United States Patent and Trademark Office

APPLICATION NO.	FILING DATE	FIRST NAMED INVENTOR	ATTORNEY DOCKET NO.	CONFIRMATION NO.	
10/695,160	10/29/2003	Howard E. Rhodes	M4065.0939/P939 7143		
24998	7590 10/12/2005		EXAMINER		
	SHAPIRO MORIN	HO, TU TU V			
2101 L Street, NW Washington, DC 20037			ART UNIT	PAPER NUMBER	
····· 35, -	-		2818

DETAILED ACTION

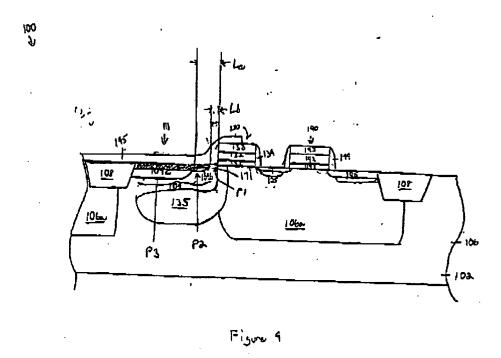
4. New corrected drawings in compliance with 37 CFR 1.121(d) are required in this application because they are not legible, for example Fig. 4, reprinted below or next page.

Applicant is advised to employ the services of a competent patent draftsperson outside the Office, as the U.S. Patent and Trademark Office no longer prepares new drawings. The corrected drawings are required in reply to the Office action to avoid abandonment of the application. The requirement for corrected drawings will not be held in abeyance.

Note: Numerical Reference 280 added by the examiner for ease of explanation

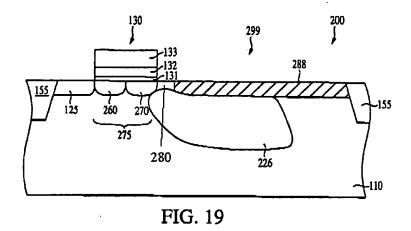
The '799 reference discloses in the figures, particularly Fig. 19, and respective portions of the specification a photoconversion device as claimed.

Referring to **claim 30**, the '799 reference discloses a photoconversion device comprising: a substrate (110, Fig. 19) having a surface;

a first region (170 or 270) doped to a first conductivity type (p, Figs. 7-19, paragraphs [0075] to [0077]) located below the surface of the substrate;

a second region (280, Fig. 19, reference 280 added by the examiner for ease of explanation) adjacent to said first region; and

a third region (126 or 226) doped to a second conductivity type (n, paragraph [0079]) located beneath said first doped region for collecting photogenerated charges (paragraph [0045]).
